Urban Design Formal Referral Response

Council Reference: PPE23/0571

Address: 300/658 Church St, Cremorne VIC 3121

Proposal: DEECA Referral

Figure 60 - 658 Church Street design objectives

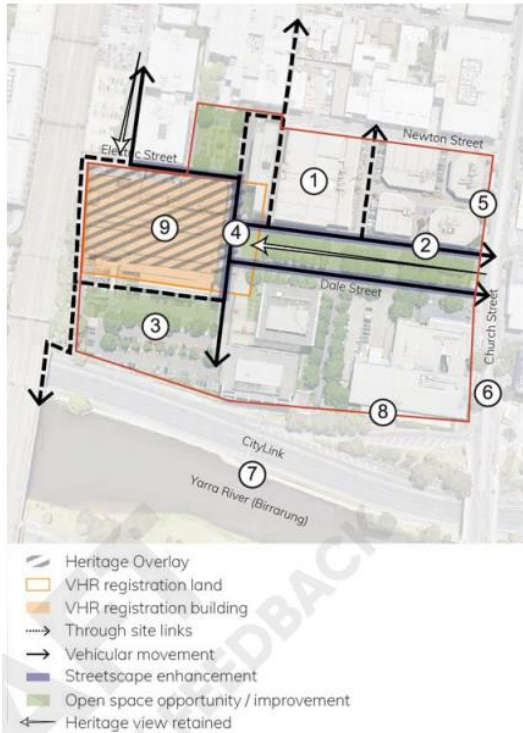
- The draft Cremorne UDF sets out a framework to guide future development in the precinct. Page 129 sets out the objectives for the 658 Church Street site, which requires a coordinated approach. The relevant objectives for this site are set out below.

- New publicly accessible open spaces are delivered that expand on the existing quality of spaces. Buildings are set within the landscape and mature trees are retained and integrated where possible.
- The public realm is upgraded to enhance the setting of The Richmond Power Station. Building massing is carefully located to ensure that the building remains prominent when viewed from Green Street and Dale Street.
- Heritage buildings will be reused or sensitively redeveloped to retain the integrity of the building and a sense of history. (NOTE - Council and landowners would need to engage with Heritage Victoria on the power station which is on the Victorian Heritage Register.)
